# Cleveland City Planning Commission

August 15, 2025

#### **AGENDA**

NE2025-019 - Rafael Valdiviseo Mural

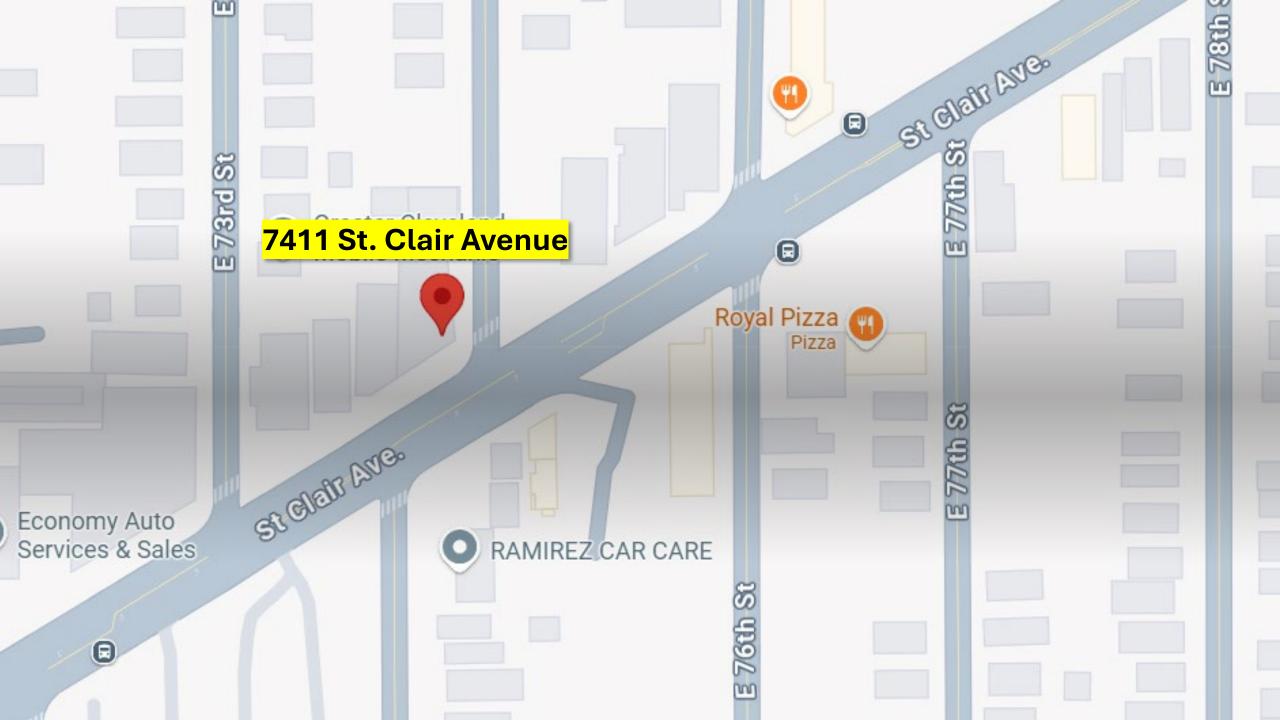
- Consider finding a way to wrap the art around a little more or pull back the art from the edge so the building finishes (clearstory window and panel beneath it) wraps the corner.
- Suggest using a lighter color paint option on the column at the corner so the detail on the capital does not get loss.

# East Stokes Block

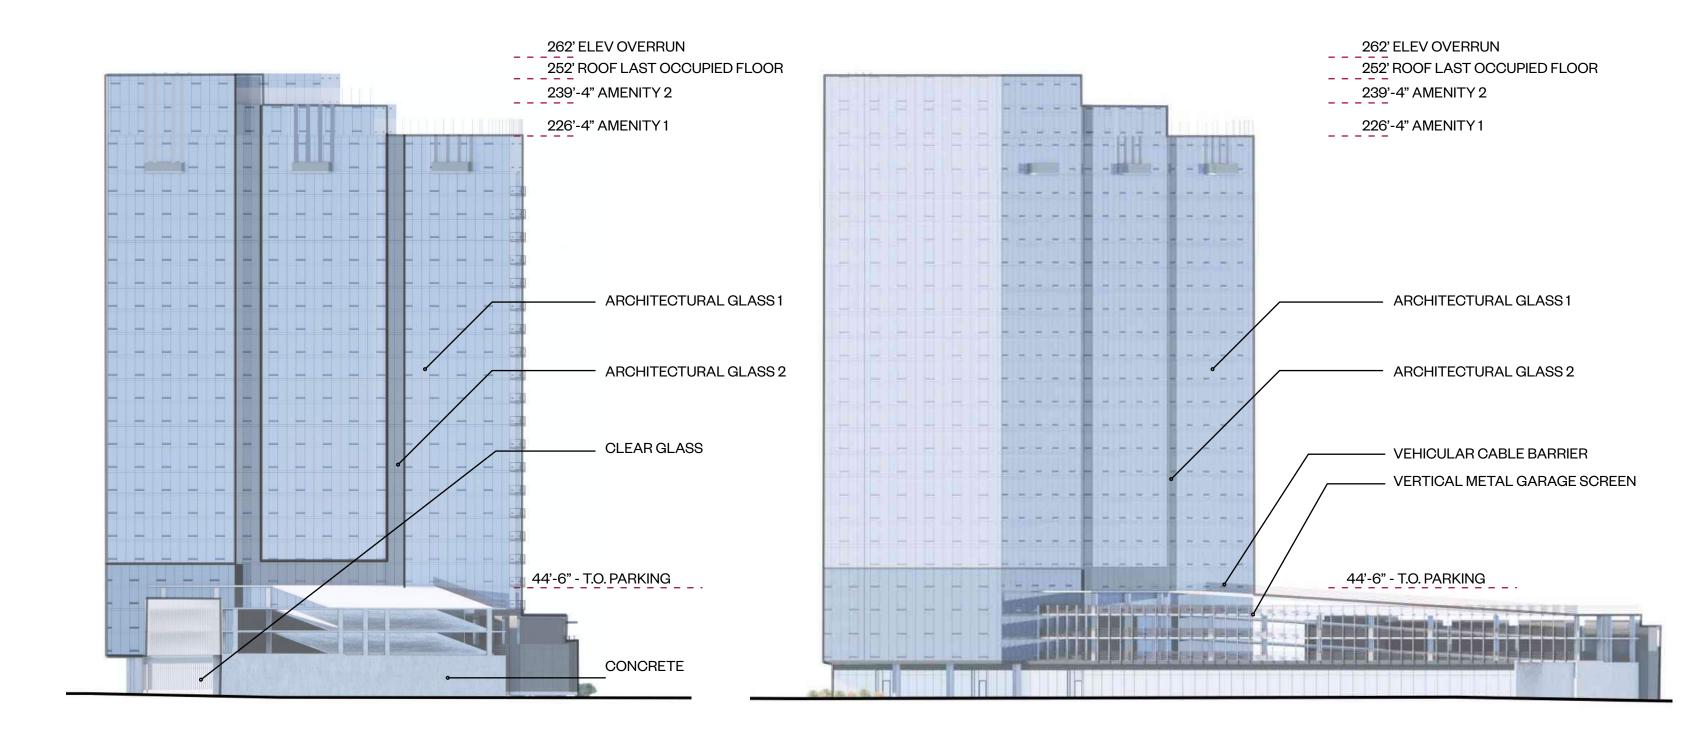
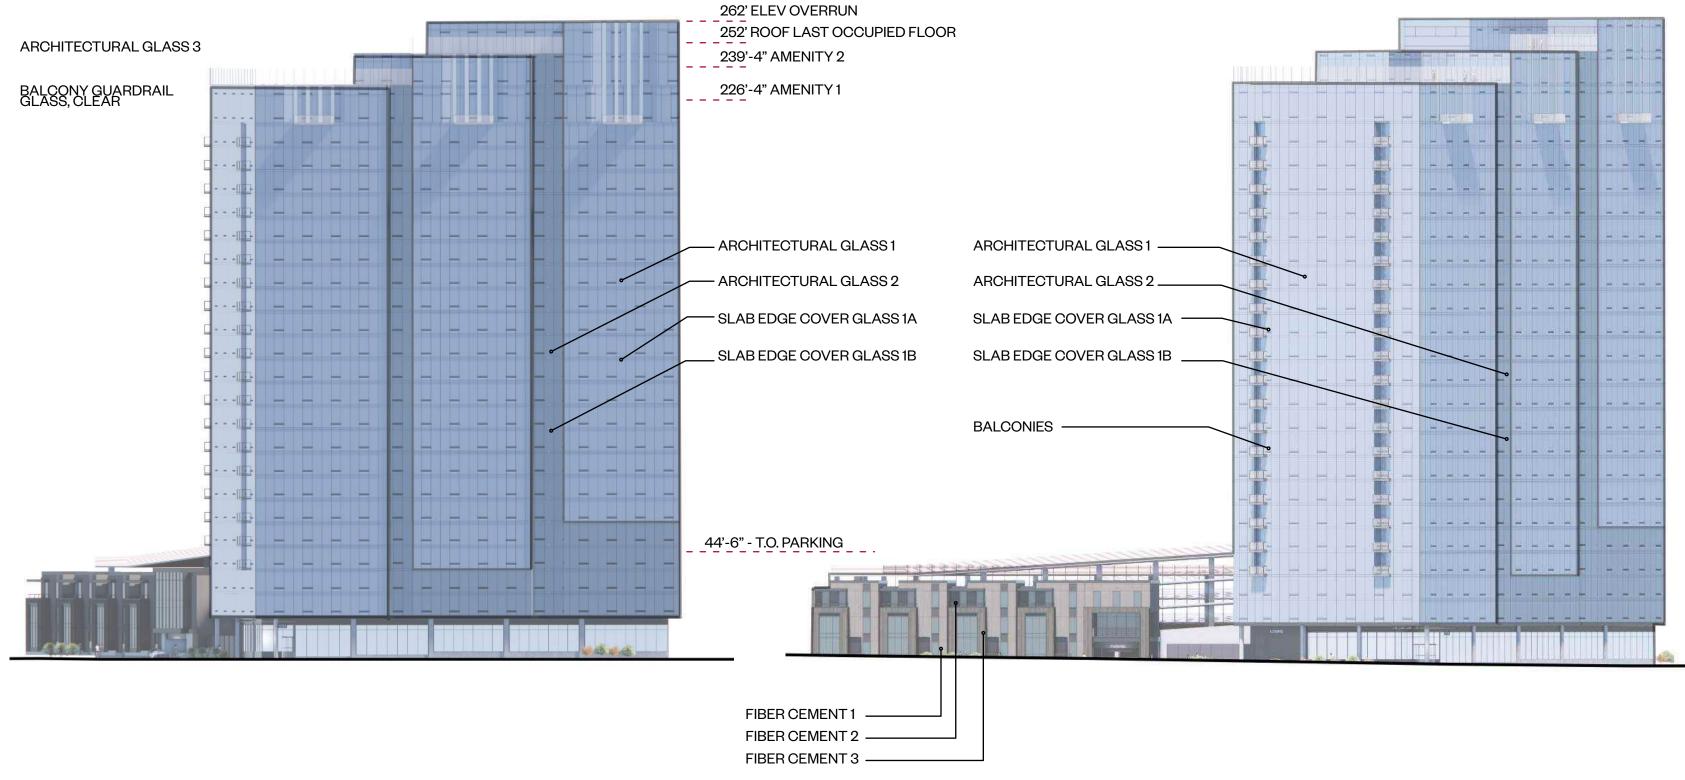
- Study how the base of the building may be tied into the townhomes, whether materials can be incorporated into building from the pedestrian level.
- Spandrel glass provide a clearer idea of how this will look in the daytime with materiality using close-up rendering of balcony and corner of building; and provide a night view showing vertical striping of spandrel verses daylit interiors.

- Large concrete wall at the garage how will it be treated? Is there an opportunity at the base for art as screening? Show interim treatment(s) between phases.

- Next steps: complete landscape & lighting plans, and detailed retail space treatment.

- This is a pivotal project for an area experiencing great resurgence of excitement in scale, activity and significance to the city
- Introduction of townhomes is an interesting element to the MLK Jr corridor and could be enhanced with additional townhomes in a subsequent phase for greater impact of presence
- Although the towers are significant in scale, the inclusion of operable windows here could add to the visual interest while the building is occupied
- Staff recommends approval of comments from DR Committee
